FINAL DECISION
TransGrid transmission
determination
2015–16 to 2017–18

Attachment 7 – Operating
expenditure

April 2015

Figure 7.1 TransGrid’s actual/estimated and proposed opex, 2009-10 to 2017-18 (\$ million, 2013–14)

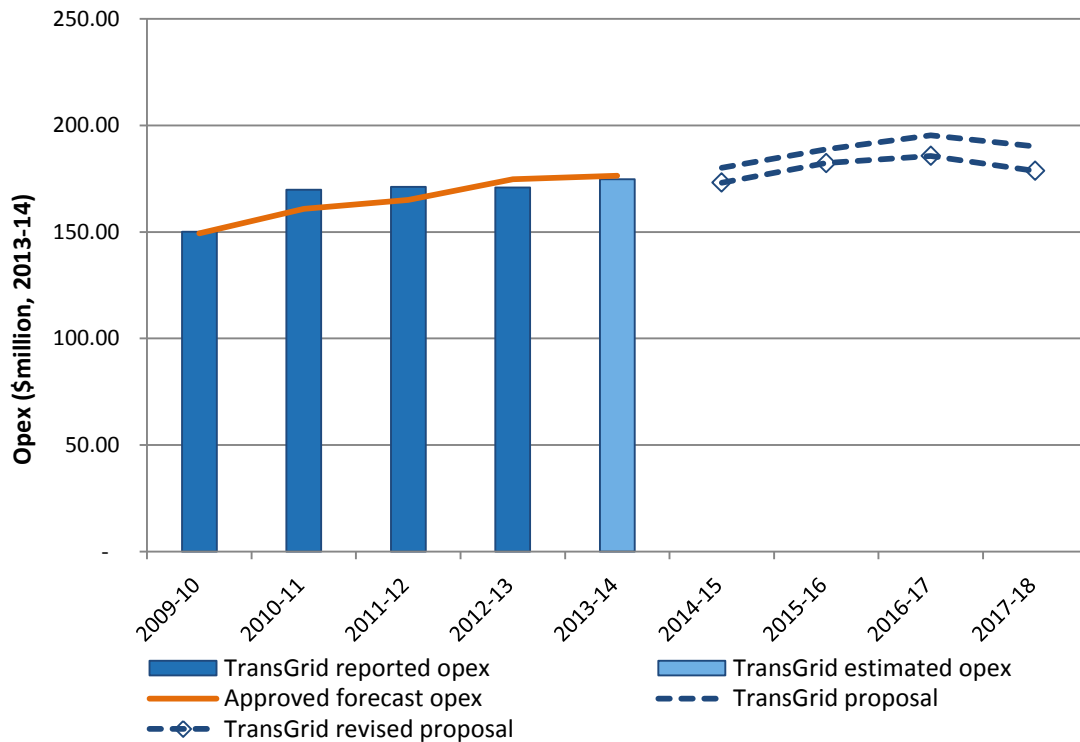
Figure 7.1 compares TransGrid's forecast opex for the 2014–18 period to its recent historical opex. The increase in TransGrid's proposed opex is mostly due to output growth, and step changes.²

Figure 7.3 AER final decision opex forecast

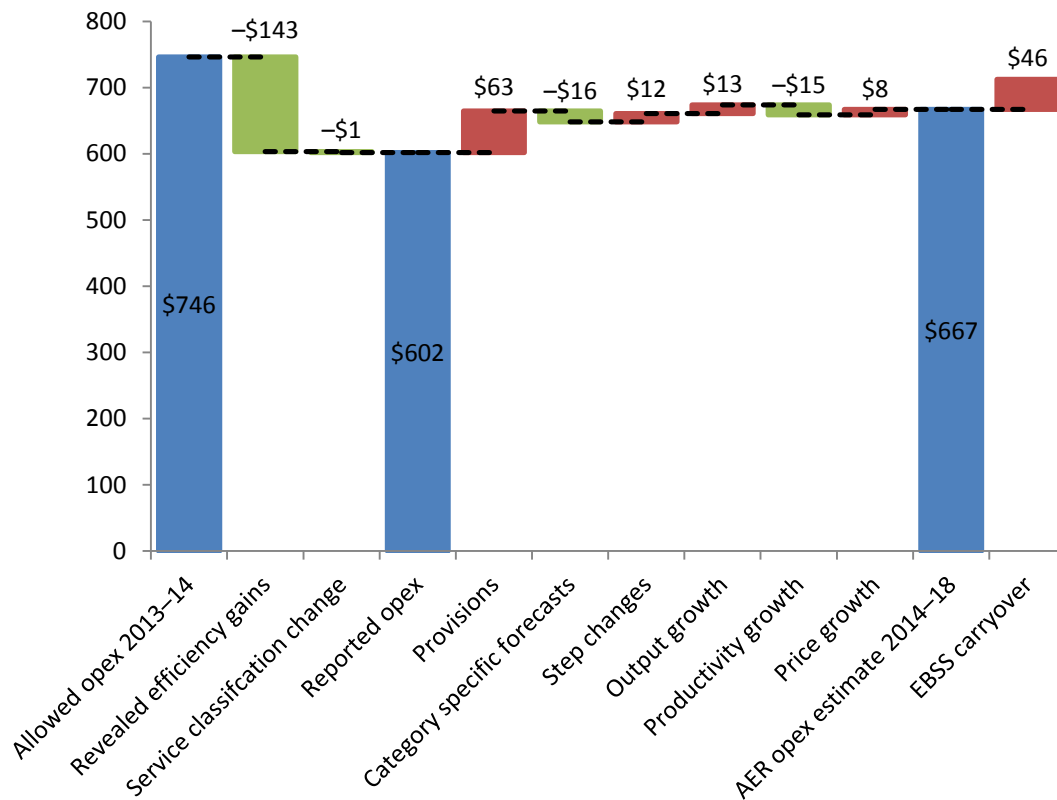
Figure 7.3 illustrates how we constructed our forecast. The starting point on the left is what TransGrid's opex for the 2014–18 period would be if we set annual opex equal to TransGrid's opex allowance for 2013–14.
